Access Compliance Report Public Rights-of-Way (Curb Ramps)

Main Street: N/A Cross Street: ROSSMOOR_CENTER_WAY Location: SE

ADA ID: RPRK211208120310 Ramp Type: Type 1 - Perpendicular Initial Pass/Fail: Fail Overall Compliance: No Severity Score: 2

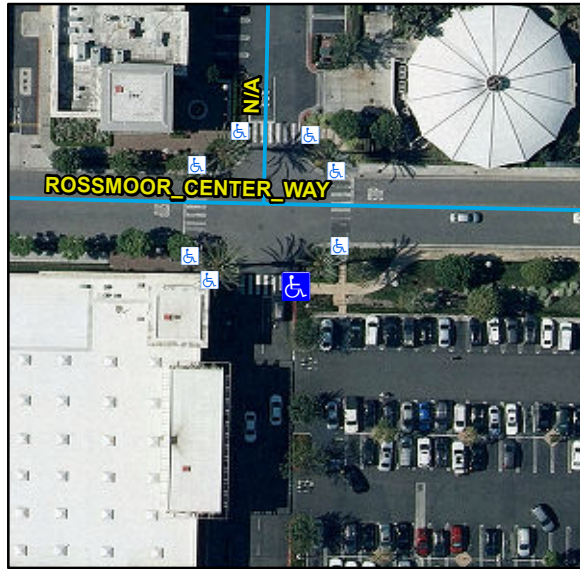
Compliance	Description	Data	Compliance	Description	Data
N/A	Ramp Length (in)	80	N/A	Flare Type LT	
Yes	Ramp Width (in)	72			N/A
Yes	Ramp Run Slope (%)	4.4	N/A	Flare Slope LT (%)	N/A
No	Ramp Cross Slope (%)	2.8	N/A	Flare Traversable LT	N/A
N/A	Landing Present	N/A	N/A	Flare Type RT	
N/A	Landing Length (in)	N/A			N/A
N/A	Landing Width (in)	N/A	N/A	Flare Slope RT (%)	N/A
N/A	Landing Run Slope (%)	N/A	N/A	Flare Traversable RT	N/A
N/A	Landing Cross Slope (%)	N/A	N/A	DWS Provided	N/A
N/A	Landing Movement Obstructed?	N/A	N/A	DWS Contrast	N/A
	Landing Movement Type	N/A	N/A	DWS Length (in)	N/A
N/A	Landing Shared	N/A	N/A	DWS Full Width	N/A
N/A	Clear Space	N/A	N/A	DWS Offset Left (in)	N/A
N/A	Clear Space To Crosswalk (in)	N/A	N/A	DWS Offset Right (in)	N/A
N/A	Marked Crosswalk 1	Yes	N/A	Marked Crosswalk 2	N/A
	Crossing 1 Direction	W		Crossing 2 Direction	N/A
	Marked Crosswalk 1 Width (in)	144		Marked Crosswalk 2 Width (in)	N/A

N/A	Ramp Inside Crosswalk 1	Yes	Yes	Ramp Inside Crosswalk 2	N/A
	Crossing 1 Slope (%)	5.3		Crossing 2 Slope (%)	N/A
	Crossing 1 Cross Slope (%)	2.8		Crossing 2 Cross Slope (%)	N/A
N/A	Gutter Ponding	N/A	No	Curb Slope	7.1
Yes	Gutter Lip Height (in)	0		Road Run Slope (%)	N/A
N/A	Gutter Run Slope (%)	N/A		Road Cross Slope (%)	N/A
N/A	Gutter Cross Slope (%)	N/A			
Yes	Overall Surface Condition: Acceptable		Yes	Perp Joint Present	Yes
	Cross Gutter Present?	No		Spandrel Present?	No
	Replace Cross Gutter?	N/A		Replace Spandrel?	N/A

Remove & Replace Entire Ramp.

R304.2.2, R304.5.3, STD 1115
